Staff Report
West Allis Plan Commission
Wednesday, June 26, 2024
6:00 PM

2. **Site, Landscaping, and Architectural Design Review for Quad, a proposed parking lot expansion at 555 S. 108th St. (Tax Key No. 414-9991-009).**

C300

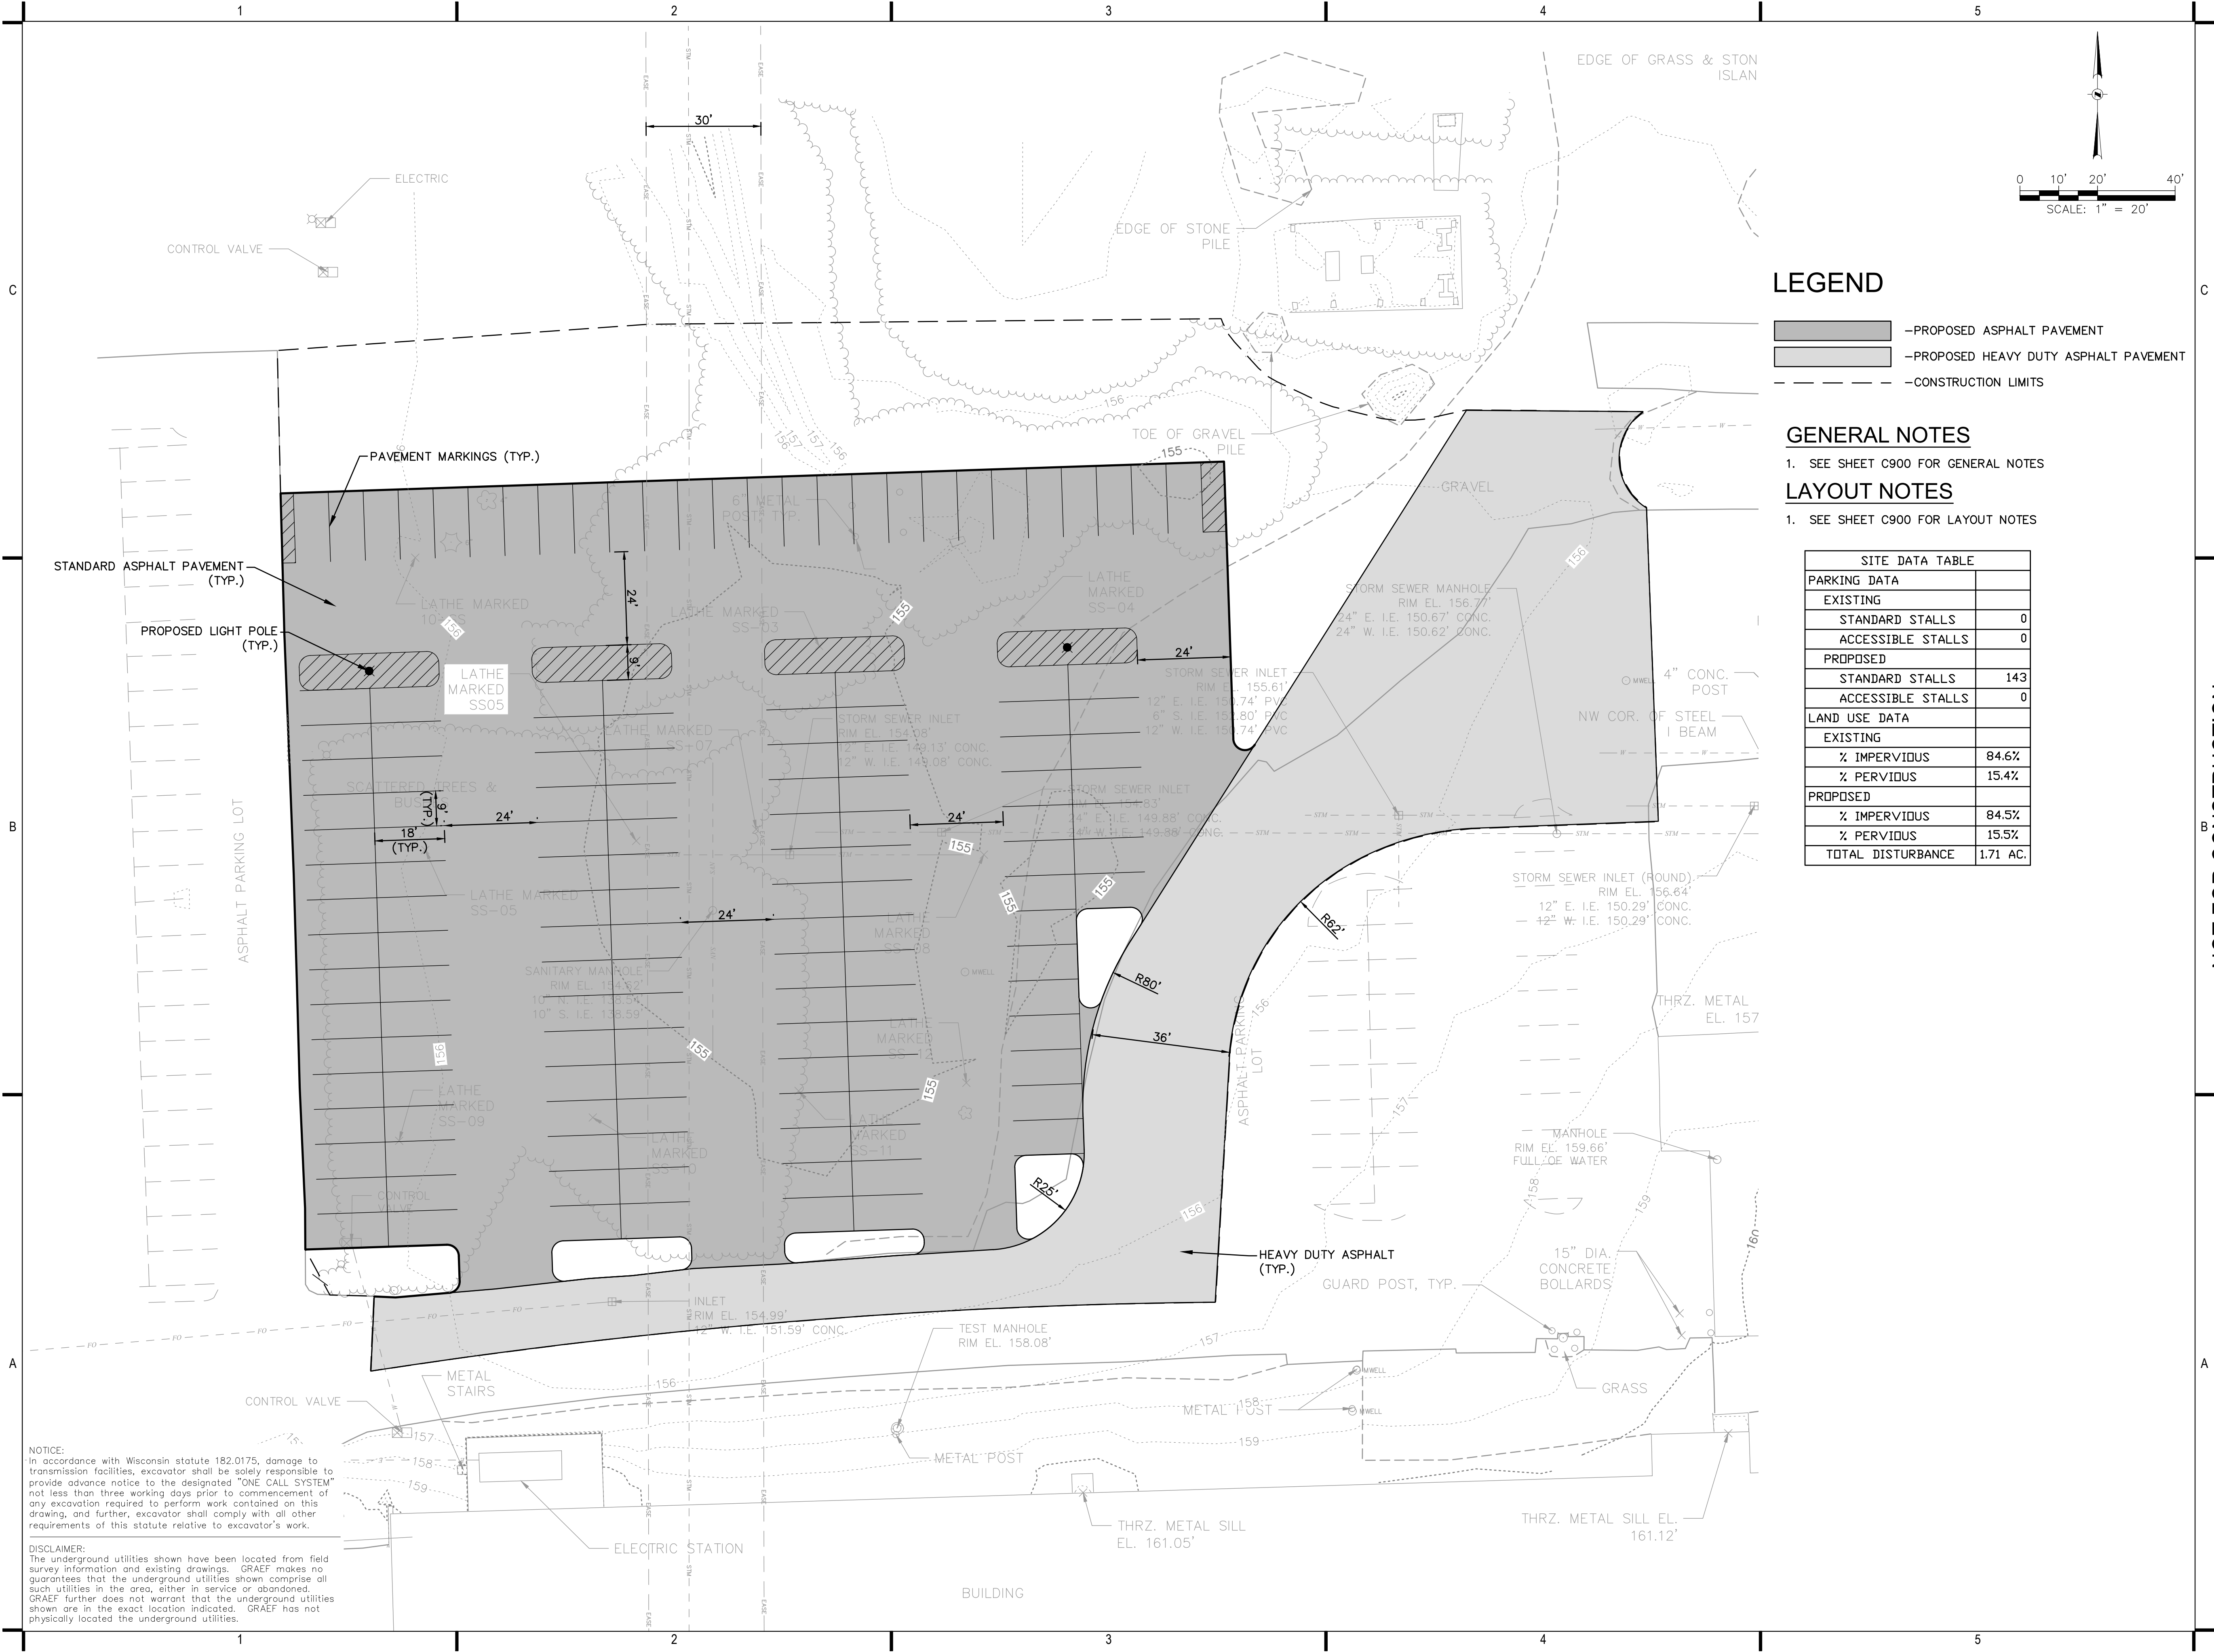
1. Revised Site and Landscaping Plans being submitted to the Planning and Zoning Department to show the following: (a) Confirmation of the number of accessible parking spaces on site and an inventory of the required number of accessible parking being provided on site in proximity to entry points (b) landscaping plan being reviewed by City Forestry. Contact Steven Schaer, Manager of Planning and Zoning at 414-302-8466.
2. Documentation and approval showing compliance with the City of West Allis Storm water Management Ordinance, to be submitted to the Building Inspections and Neighborhood Services Department by a registered Civil Engineer. A storm water permit must be obtained from the City. Contact Mike Romens, Plumbing Inspector at 414-302-8413.
3. Lighting plan being submitted for review by the Planning and Zoning Department.
